**PLANNING DEPARTMENT REPORT
YARMOUTH, MAINE**

Minor Site Plan

Accessory Dwelling Unit, 538 Portland Street

Date: August 16, 2021

Building Layout

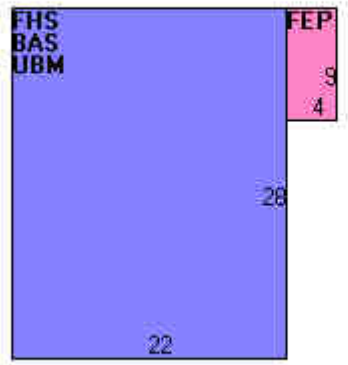
-Based on the applicant’s documentation, the property appears to be 916 square feet. The applicant appears to have arbitrarily subtracted floor space on the second floor that is usable and accessible but has a nominal ceiling height of less than 5’. Furthermore, according to the Vision Government Solutions Assessors on-line database, the proposed ADU at 538 Portland Street is listed at 924 square feet (finished living area, not including basement or porch). Both sources indicate the proposed ADU is in excess of the square footage requirements.

Town Comments: The applicant has indicated the floor area of the unit to be 717 SF. This appears to be based on the interior livable area which the Planning Department has deemed to be an acceptable approach. Livable area does not include closets, stairwells, shafts, or other non-habitable spaces. In spaces with sloped ceilings, habitable space should only be calculated for the area having a ceiling height of five feet or greater in accordance with industry standards including 2015 International Residential Code (IRC)/ R304.3 *Height effect on room area*. The assessor's information indicates the Living Area as 924 SF, which is based on the exterior dimensions of the house and accounts for the discrepancy in the two numbers.
